Proposal for a supplement to 01 series of amendments to UN Regulation No. 152 (Advanced Emergency Braking System for M₁ and N₁ vehicles)

The text produced below was prepared by the workshops group on UNR-R 152 and is based on working document GRVA/2023/22. The proposal is aimed at allowing the applicant to use virtual testing methodology as alternative methodology to the physical tests. The modifications to the existing text GRVA/2023/22 are marked in bold red for new or strikethrough for deleted characters.

Figure 5

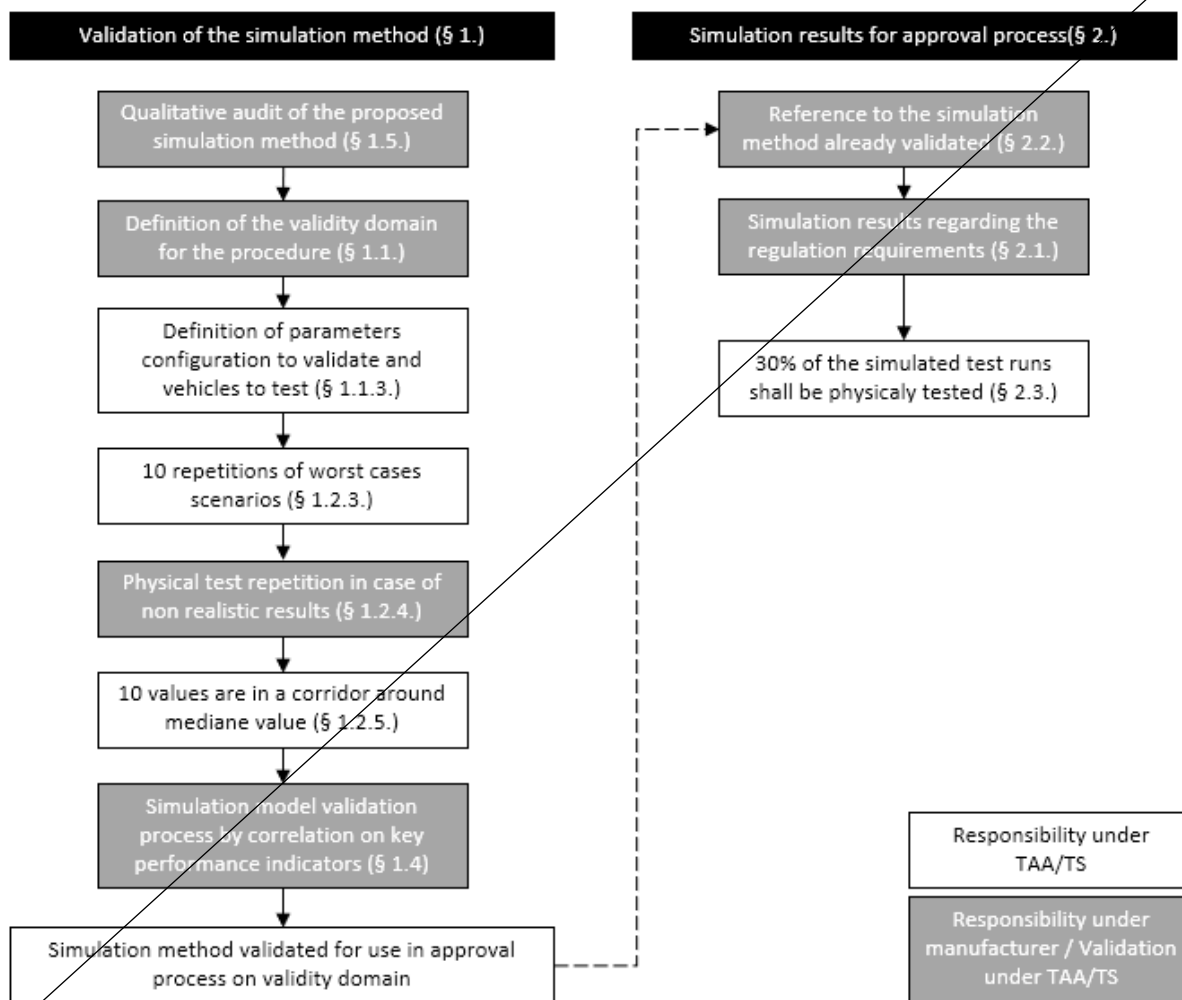
~~This global approach is summarized step by step in the scheme below figure 5 and further detailed in the following chapters.~~
